SUBMITTAL IDENTIFICATION SHEET

WEBSTER UNIVERSITY ISB
PROJECT NAME

098433-004
CONTRACTOR / CM SUBMITTAL NO.

Acoustical wall panel samples

SPECIFIED COLOR
GRAPHITE
ROOM 160 B CONTROL
Snoopy
Graphite
098433
FAP - 1
NATIONAL WALLCOVERING
ECORE PANEL
098433
AP - 1
FABRIC: MOMENTUM
UNIVERSE - COSMIC
- LECTURE HALL 160
Shift
Ctrl

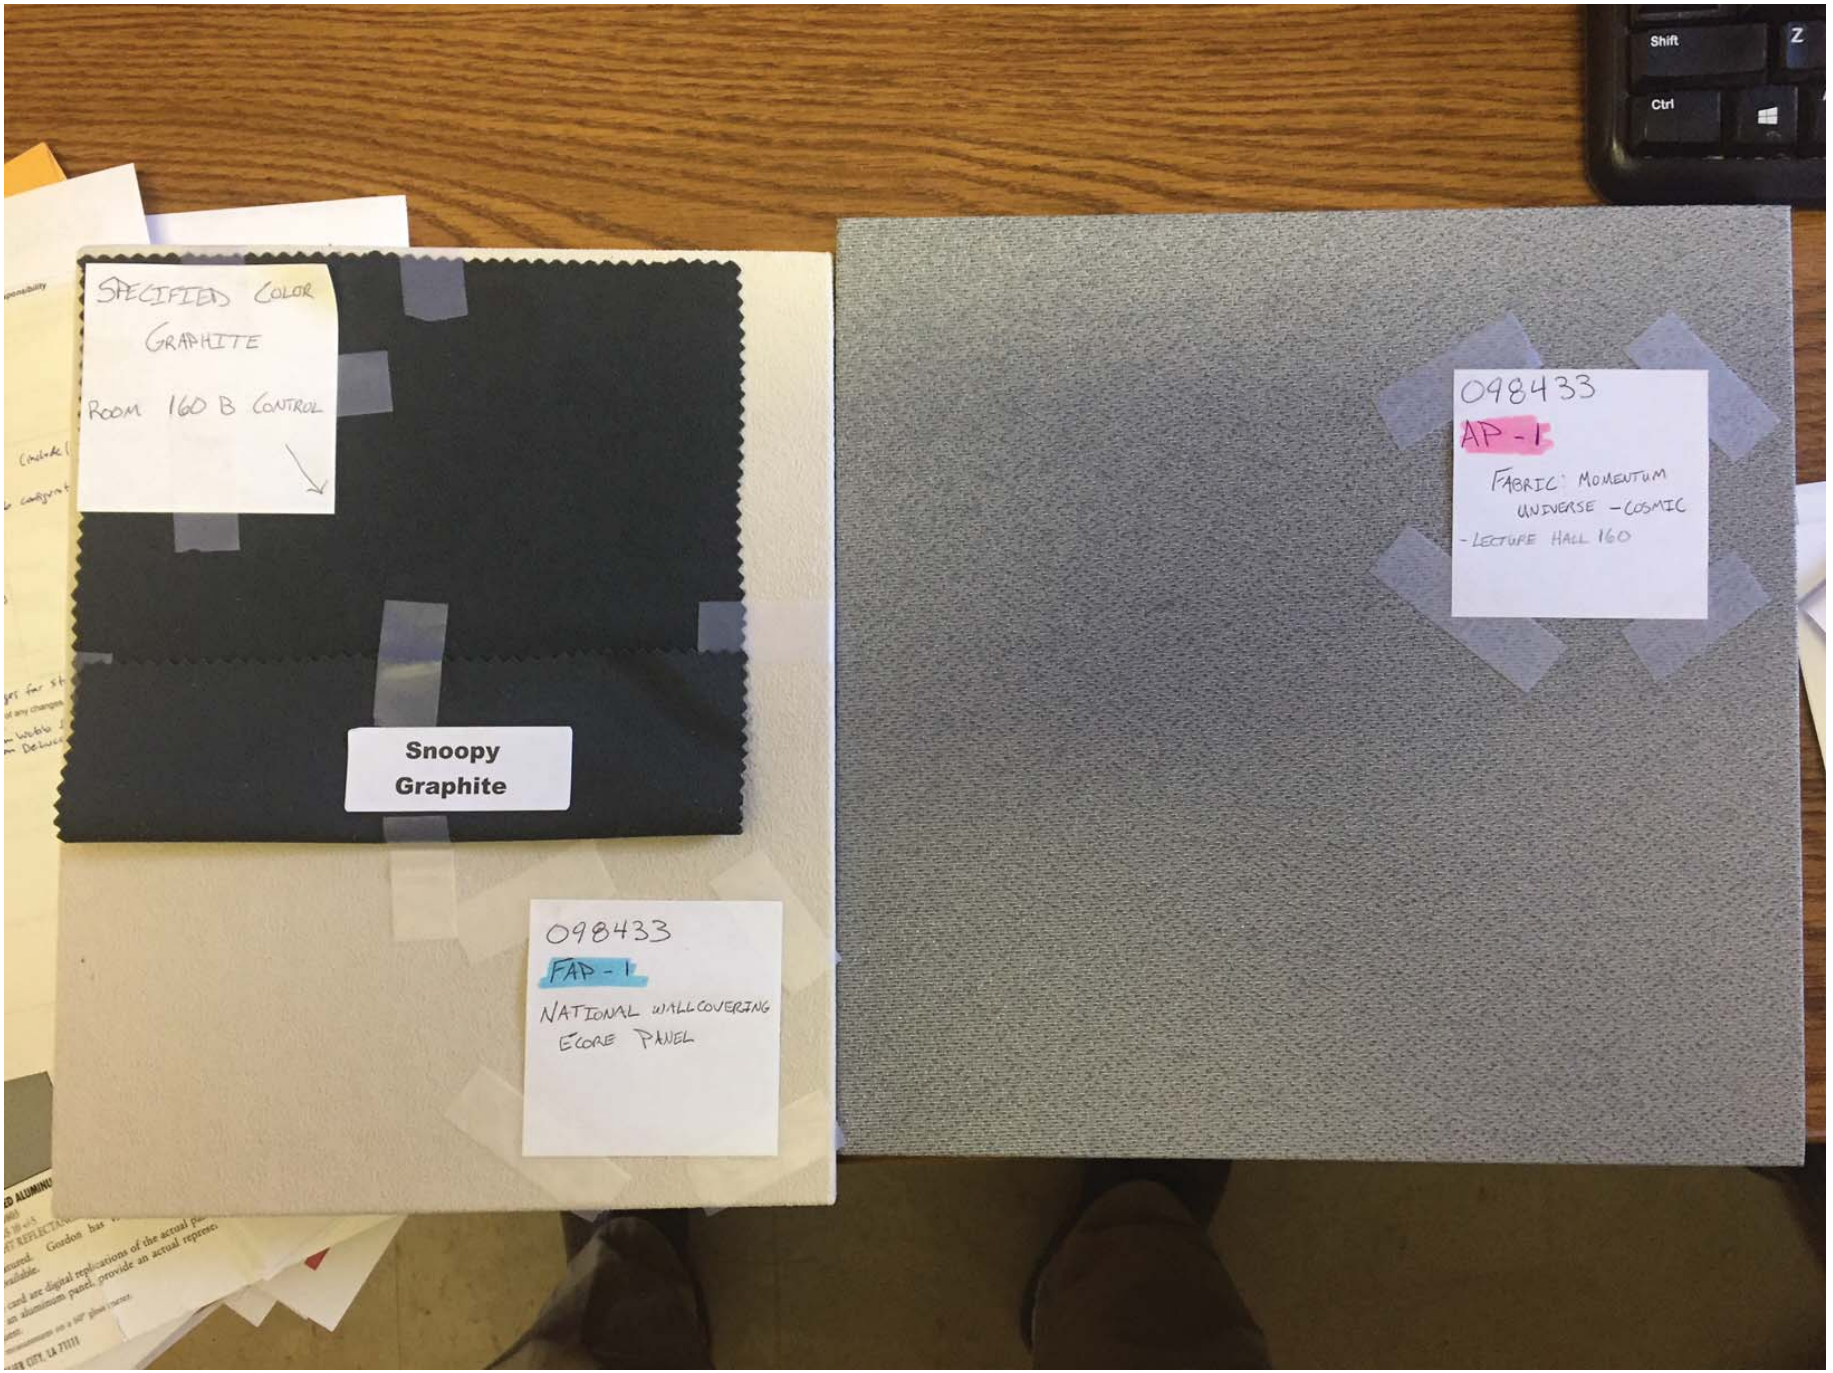
Resubmit 'FAP-1' sample with appropriate core (Fiberglass core) to have NRC of 0.85 per specification.

Provide NRC for 'AP-1', per specification NRC of 0.85 required.
